Minor Material Amendment : Description of Proposed Change

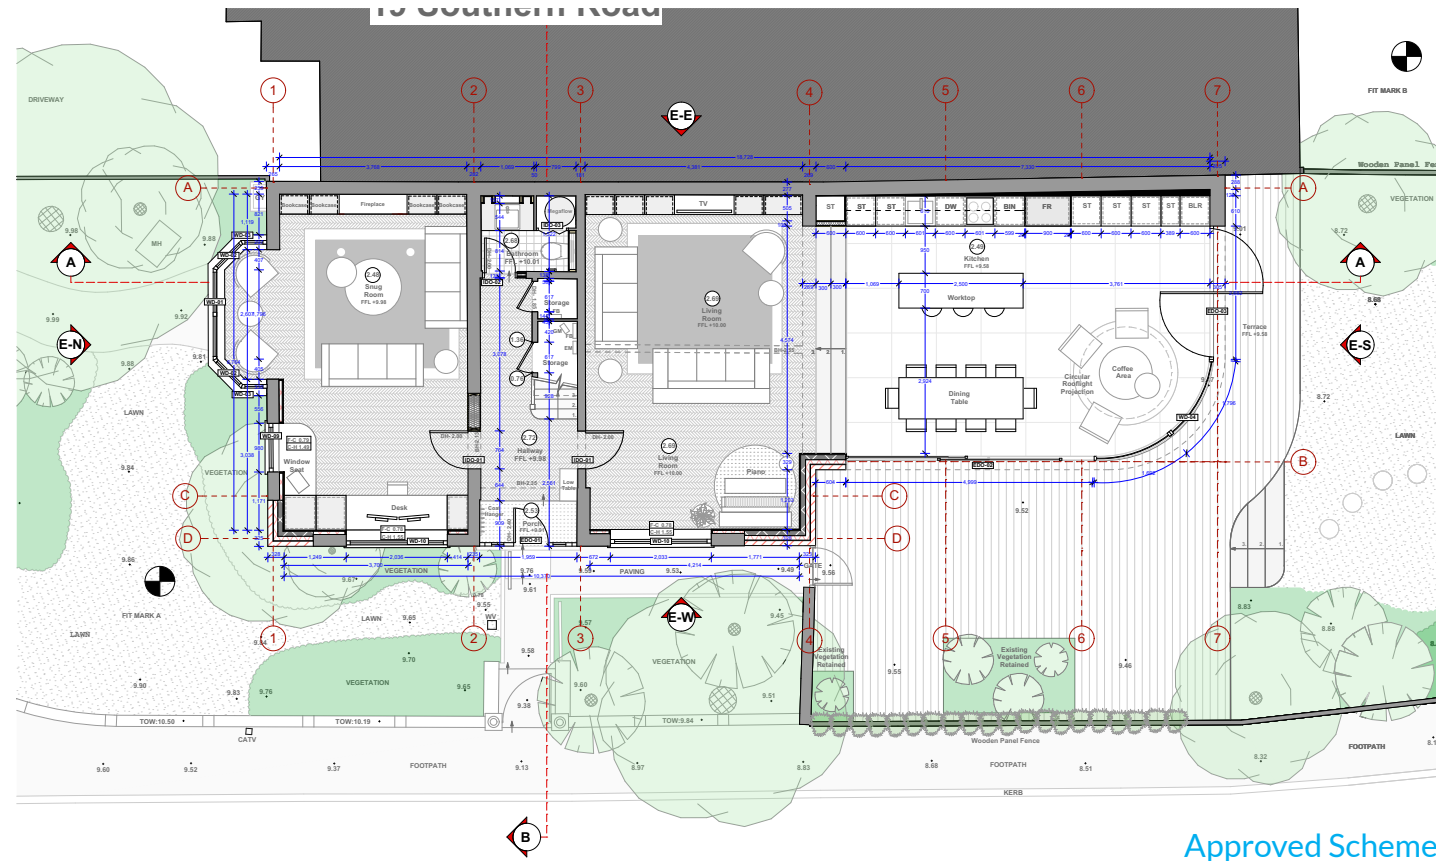
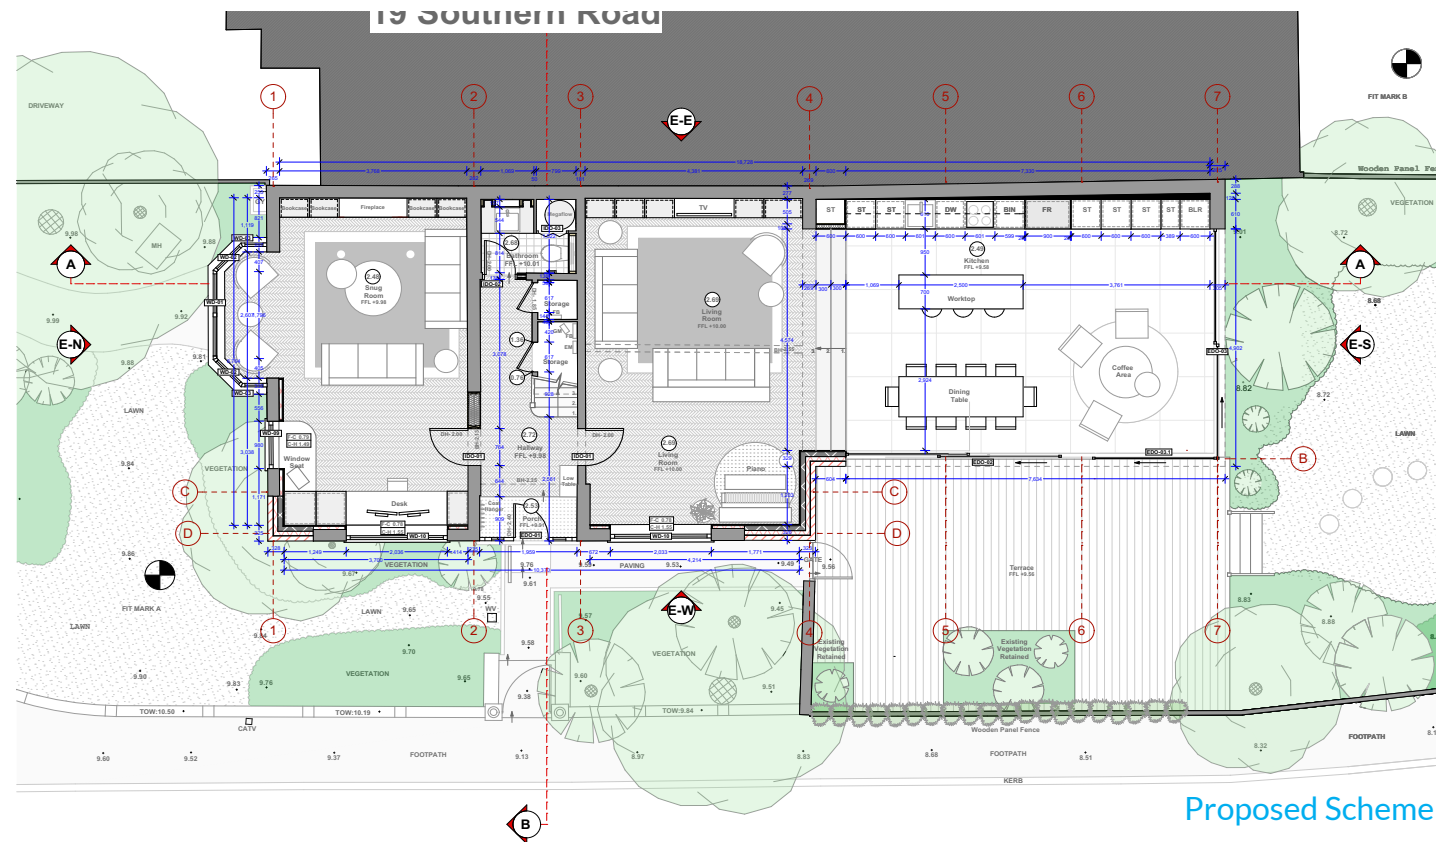
One of the principal cost concerns was the bespoke curved glazing proposed at the corner of the rear extension, together with the associated structural requirements, including a curved steel beam. Following discussions with several contractors, it was confirmed that the curved glazing and supporting structure would represent a significant additional construction cost and would also introduce greater complexity to the construction process.

To provide a more straightforward and cost-effective construction solution, it is therefore proposed to square off the corner of the extension, replacing the curved glazing arrangement with a conventional straight junction. This amendment will simplify the structural and construction requirements while retaining the overall design approach and appearance of the extension.

As part of the wider cost-reduction exercise, it is also proposed to retain the existing ground-floor terrace arrangement, rather than constructing the previously approved extension to the terrace, and to omit the circular rooflight within the proposed green roof.
